State of New Mexico  
 Energy, Minerals and Natural Resources

Form C-103  
 Revised August 1, 2011

WELL API NO. 30-025-31281
5. Indicate Type of Lease STATE <input checked="" type="checkbox"/> FEE
6. State Oil & Gas Lease No.
7. Lease Name or Unit Agreement Name LOVINGTON PADDOCK UNIT
8. Well Number #109
9. OGRID Number 24133
10. Pool name or Wildcat LOVINGTON PADDOCK (40660)

SUNDRY NOTICES AND REPORTS ON WELLS  
 (DO NOT USE THIS FORM FOR PROPOSALS TO DRILL OR TO DEEPEN OR PLUG BACK TO A DIFFERENT RESERVOIR. USE "APPLICATION FOR PERMIT" (FORM C-101) FOR SUCH PROPOSALS.)

## LPU 109 WELLBORE DIAGRAM

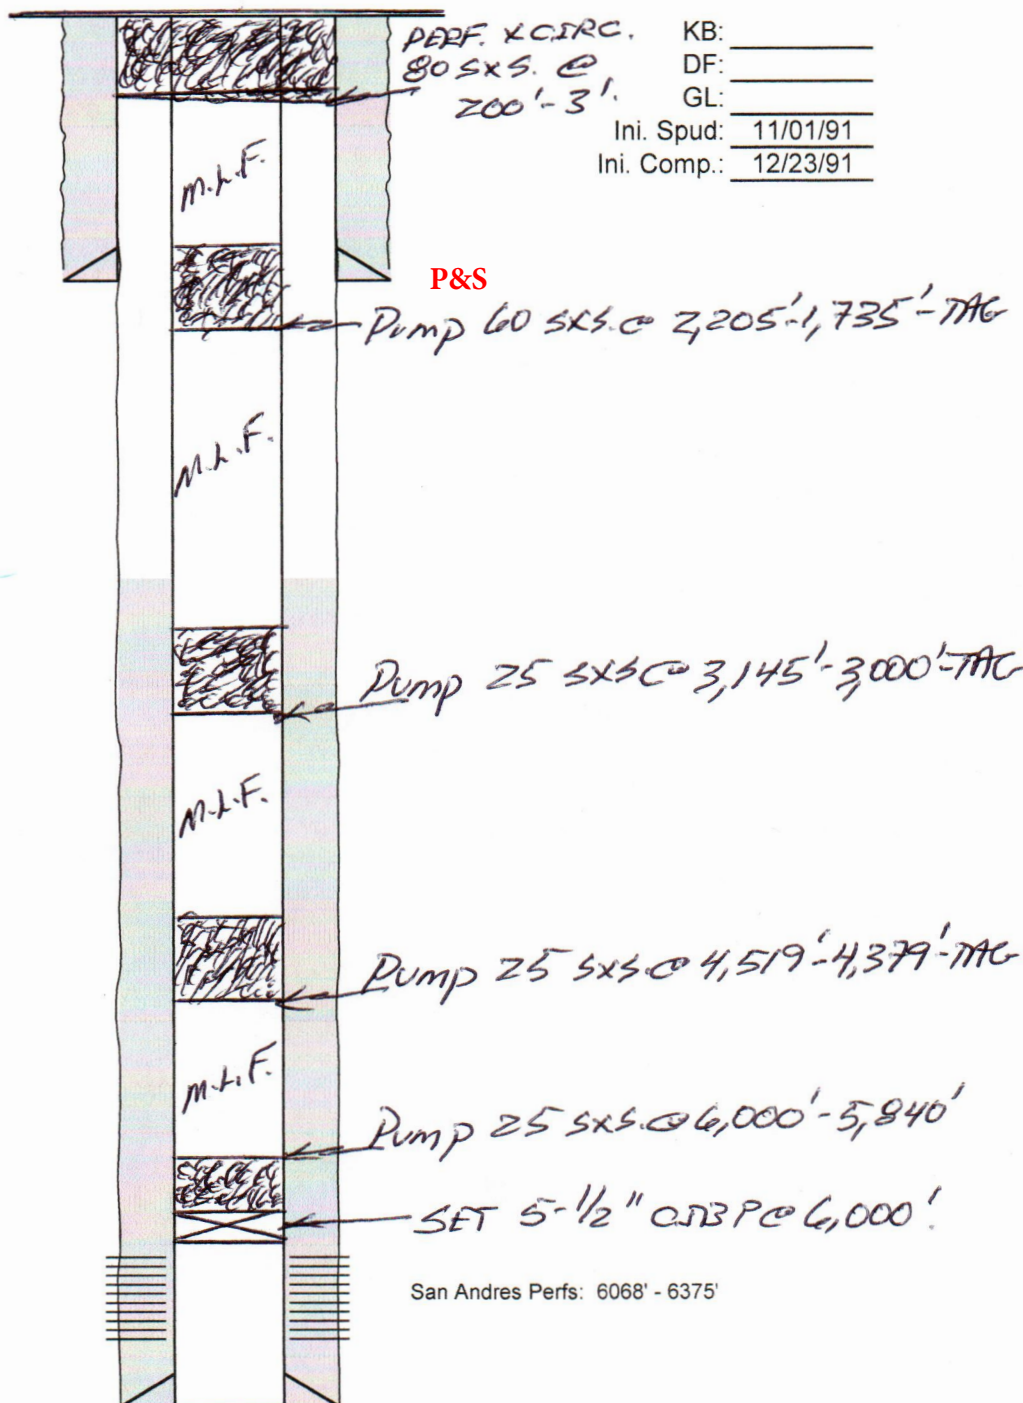
4" diameter 4' tall Above Ground Marker

Operator: CHEVRON MIDCONTINENT, L.P. 6301 Deauville Blvd Midland, TX79706			OGRID: 241333	Action Number: 14875	Action Type: C-103F
OCD Reviewer	Condition				
kfortner	See attached condition of approval Note changes in procedure
